A Public Meeting was held on September 26, 2018 to present existing conditions data and receive public comment on the VT 22A Truck Route Study. Comments made at the meeting were recorded by Stantec in meeting notes. These comments are listed below along with the responses prepared by the project team.

Figure 1 VT 22A Truck Volumes Just North of VT 17

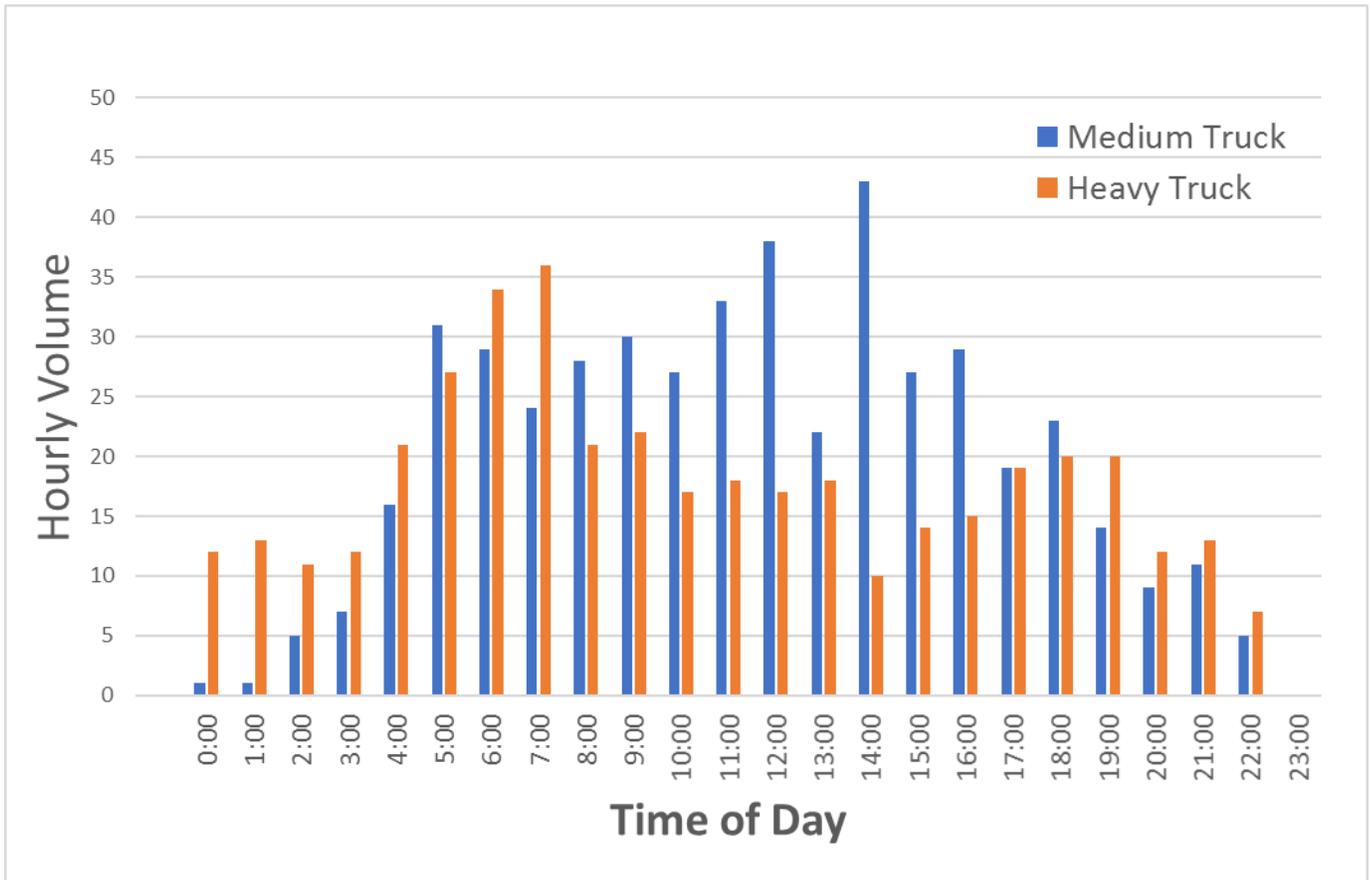
**Comment 7:** Consider the effect of noise at different times of the day and night.

**Response:** The study team understands that truck noise impacts vary by the time of day or night that they are experienced. VTtrans periodically conducts vehicle classification counts on major roadways. Hourly truck volumes collected on VT 22A 1.2 miles north of VT 17 on August 31, 2018 are shown in Figure 1. As indicated, at least ten large trucks per hour use VT 22A for 23 out of 24 hours per day.
